L-2009-185
10 CFR 52.3(b)(2)

Re: Florida Power & Light Company
Proposed Turkey Point Units 6 & 7
Project No. 763
Supplemental Information – COL Application Part 2
Final Safety Analysis Report Sections 2.5.1 and 2.5.2

FSAR Chapter 2

Development of Crustal Attenuation Models for the Caribbean Region for use in PSHA

Figure 1a. Attenuation curves for M7 and PGA.

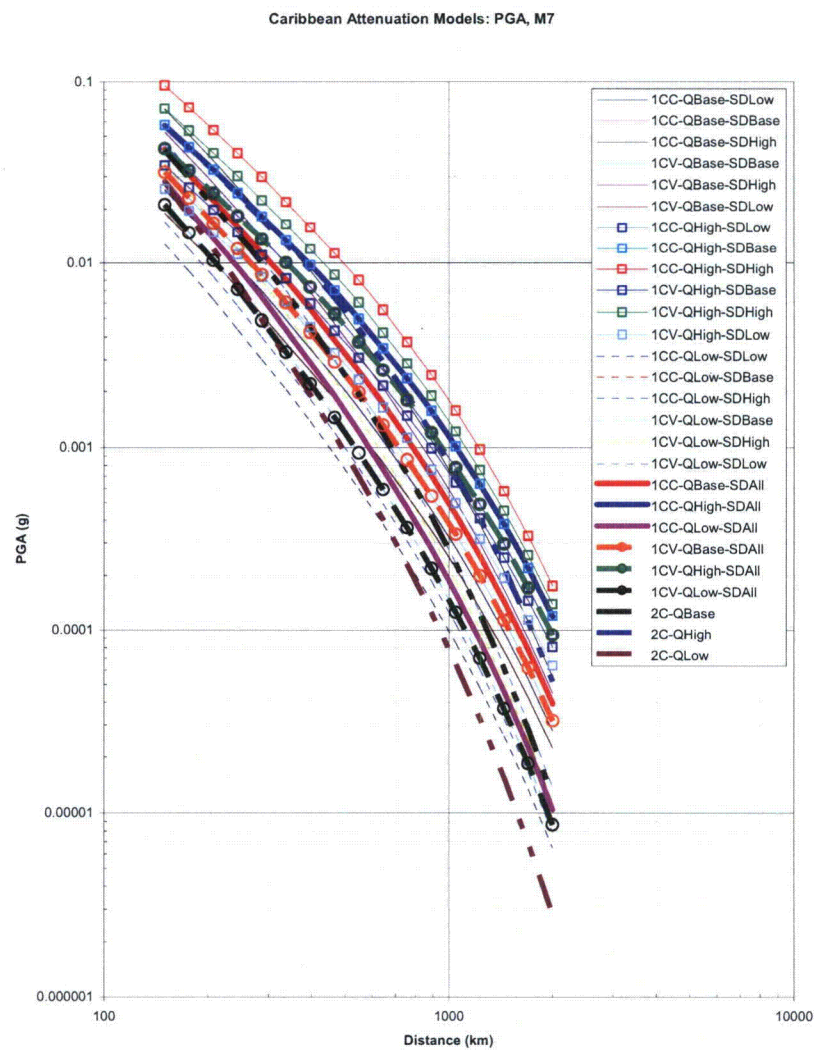
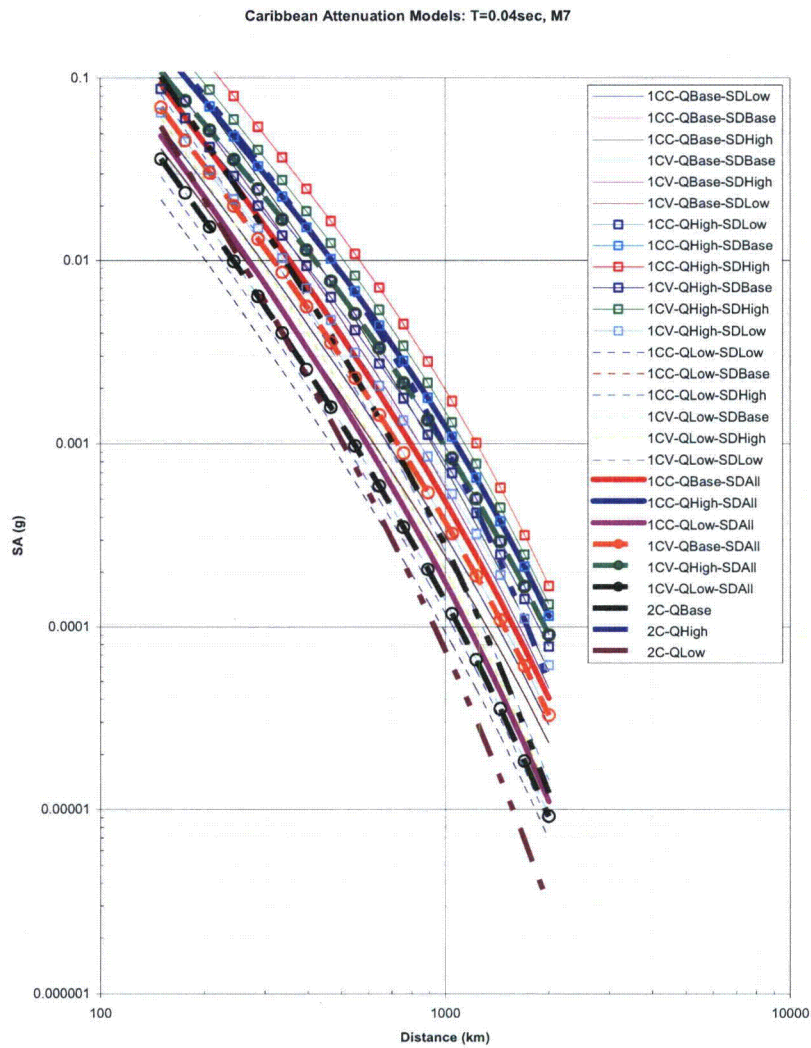
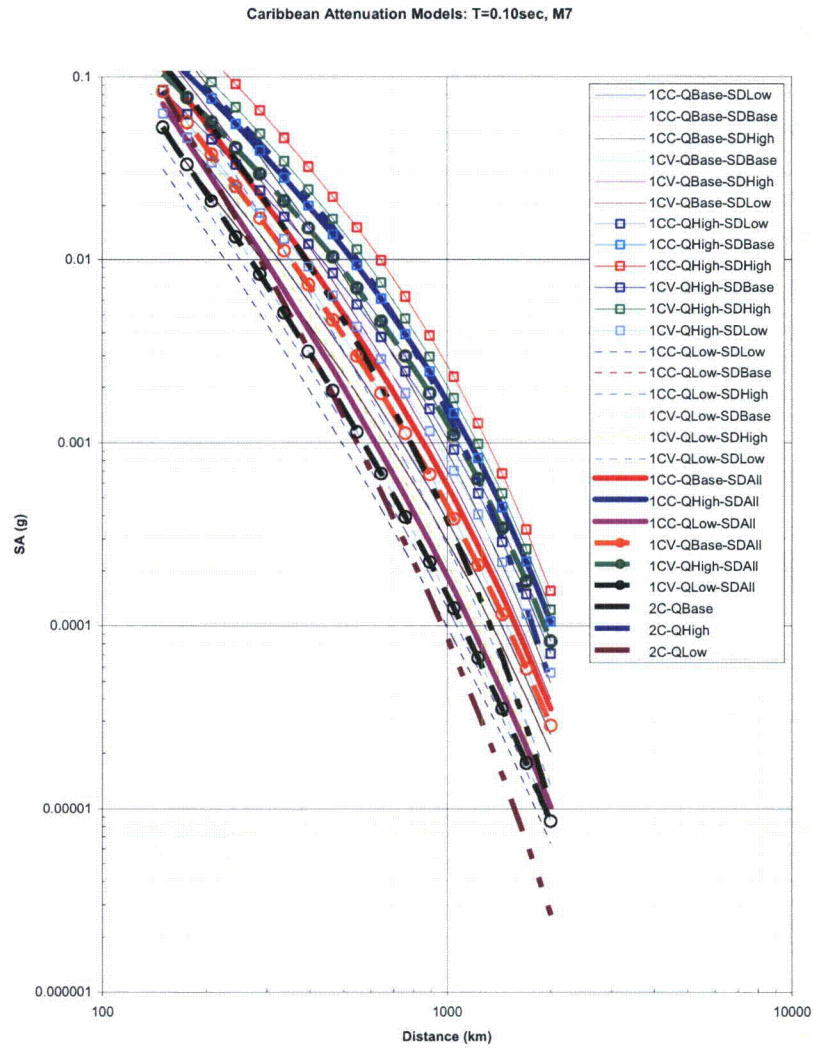
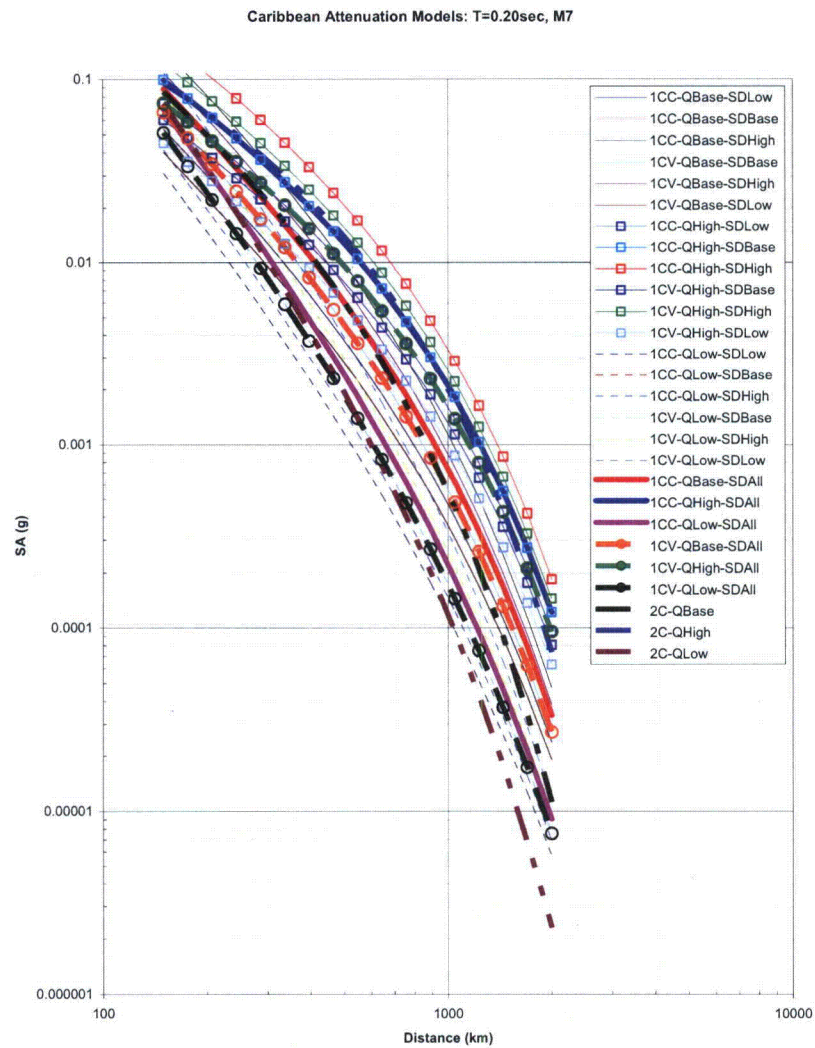
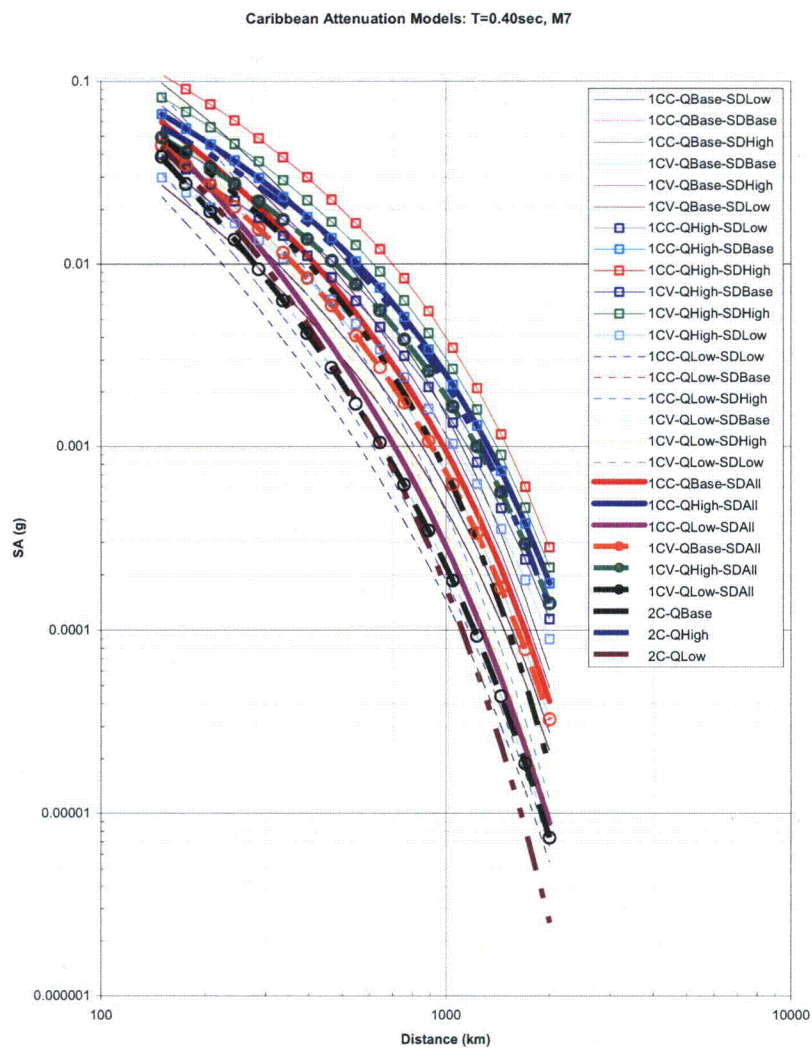
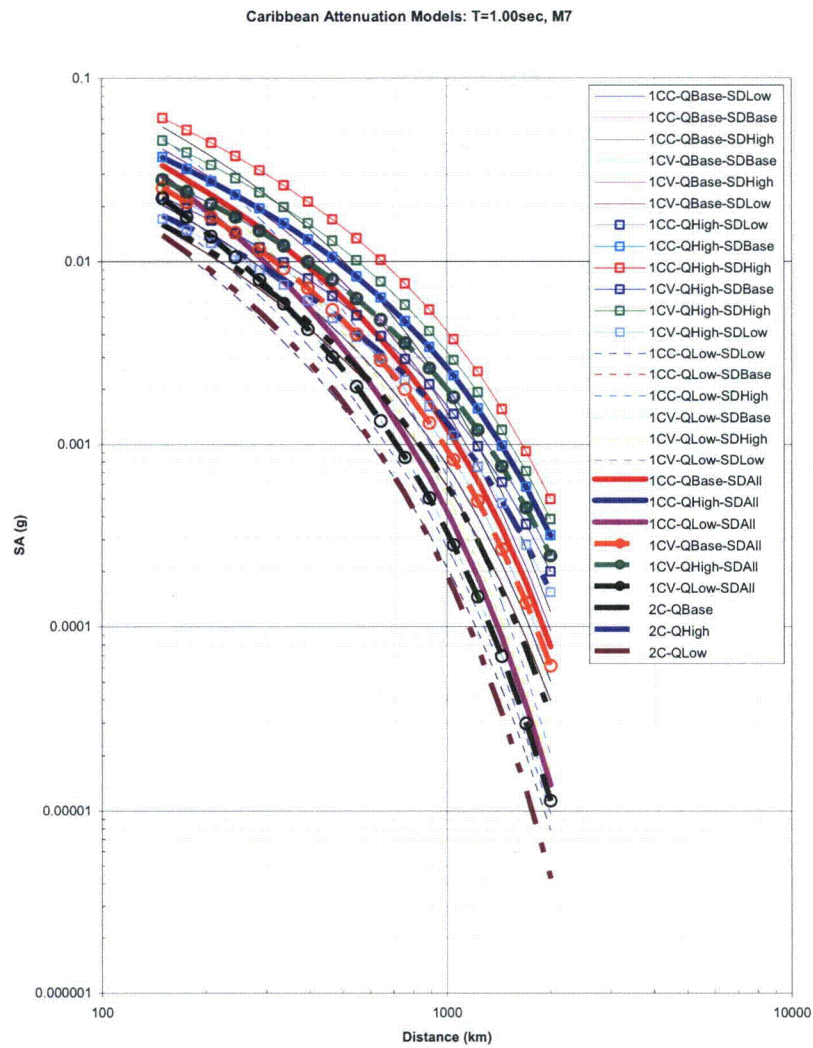
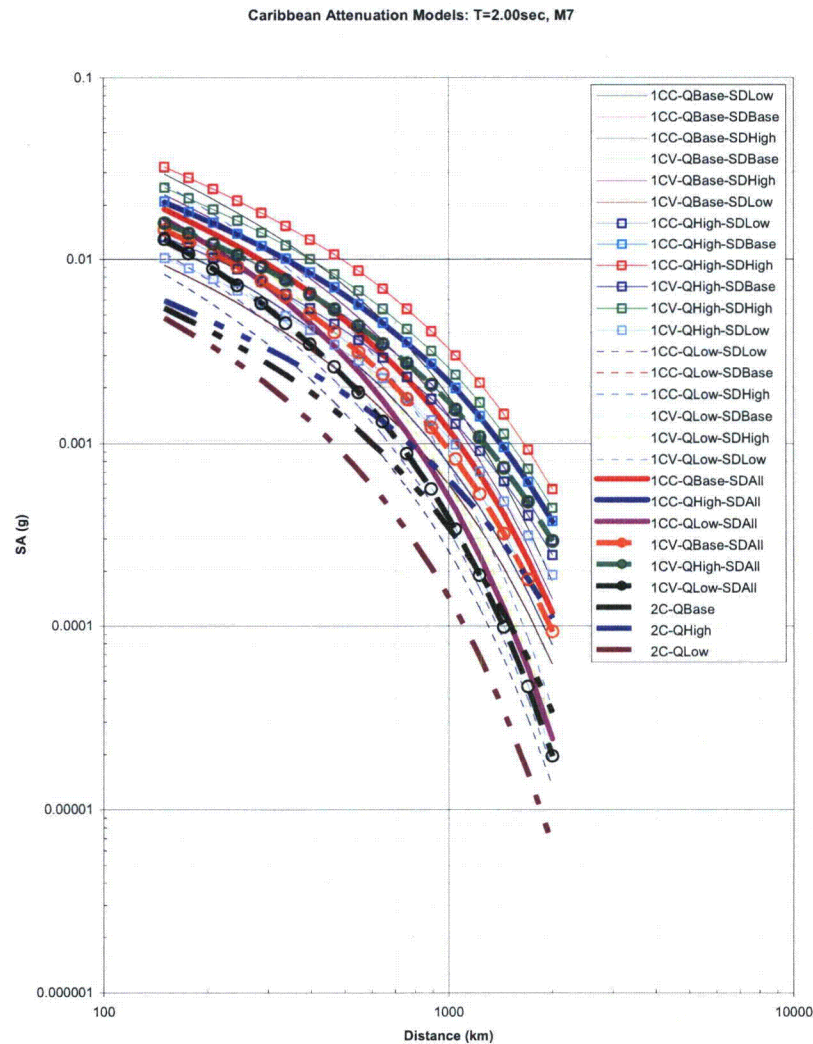
- NRC indicated that FPL should provide more detailed information on the geologic history and tectonics in the 200 mile radius of the site.
- NRC indicated that FPL should provide more detailed information on the development of Crustal Attenuation models for the Caribbean Region for use in Probabilistic Seismic Hazards Analysis (PSHA).

The regression ground motion models are plotted in Figure 1 for the seven frequencies of interest as a function of distance for a magnitude 7 earthquake. The thicker attenuation curves represent the final nine attenuation models while the thinner curves show the individual attenuation models which were developed during the analysis. In general, the nine models span a range in ground motions between factors of approximately 2 to greater than 10 at the largest distances. Based on this observed range in ground motions from the suite of models, it was concluded that no additional epistemic uncertainty would need to be considered in the PSHA if the complete suite of nine models were used.
